AERONAUTICAL CHARTING MEETING
Instrument Procedures Group
Meeting 22-02 – October 24-25, 2022

RECOMMENDATION DOCUMENT

FAA Control # 22-02-370

Subject: 8260.3E Figure 2-7-2 Misleading

Figure 2-7-2. Simple Restricted Circling Area

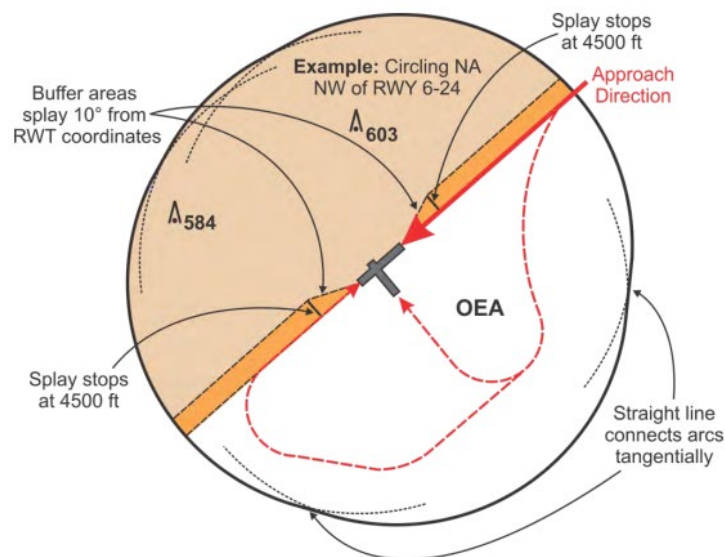
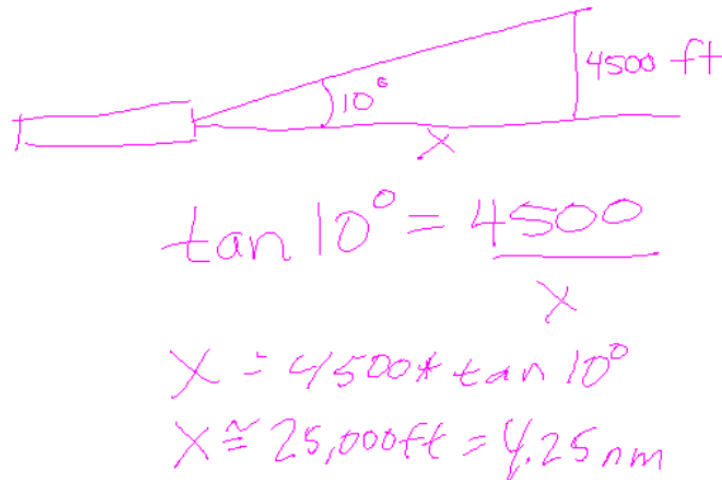
Figure 2-7-2 is at issue because it suggests the splay ends well within the circling area; however, applying the text-described formula leads to the splay stopping 4.25nm from the LTP,

Thus, the image in 2-7-2 is misleading because splay, all the way up to Category D below 7000ft MSL, extend to the edge of the circling area.

A cursory glance at figure 2-7-2 may lead one to assume the splay stops 4500ft away from the LTP.

Updated 8260.3E with a diagram more representative of the splay geometry.

visualize the area, noting he was not aware of any problems caused by the diagram and does not see a concern. Dan said he will look at either fixing or deleting the figure and does not see a need to track this in the ACM. Dan added there are many figures that may need revision throughout the orders and requested they be sent to him as identified. Jeff said the issue will be reviewed by the ARRG.

Meeting 23-01: Jeff Rawdon, FAA Flight Procedures and Airspace Group (FPAG), briefed the summary, actions, and status from the ([slide](#)). The graphics have been revised and will be in the Order 8260.3 release this summer. The example [slide](#) was shown for the revised figure 2-7-2, and the issue was closed.
